Addendum No. 3

17-05B - Sunset Point Park Playground Fence

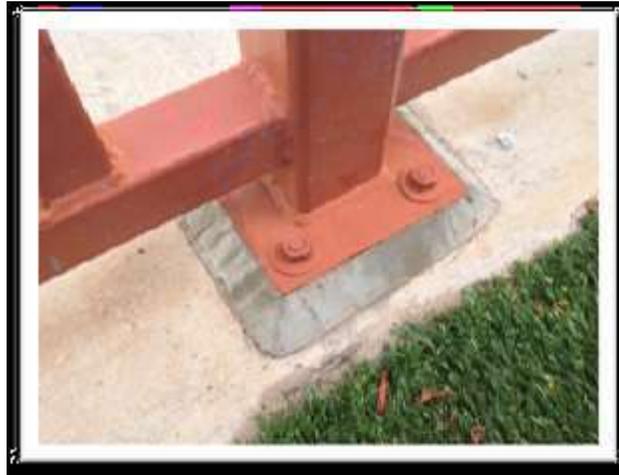
1. The new bid opening date for this project is 01/19/2016 at 3:00 PM.
2. Please add the following information to the bid:
 - The Powder Coat Finish for the fence shall be Sherwin Williams Powdura® 4000 Super Durable TGIC Free Polyester, medium gloss, applied to over 2 mils thickness and complying with AAMA 2604.
 - An additional clear-coat finish over the powder coating is not required.
 - The proposed man gate shall be self-closing with closing rate controlled hinges (hydraulic) and child proof automatic latch (Manga Latch)
 - Fencing Hardware (i.e. fasteners) shall be 18-8 stainless steel conforming to ASTM A276
 - The number of art panels (i.e. hand painted design motifs) will be dictated by the actual fence layout, in accordance conceptual plan using two fill in panels between the design hand painted panels (see below)
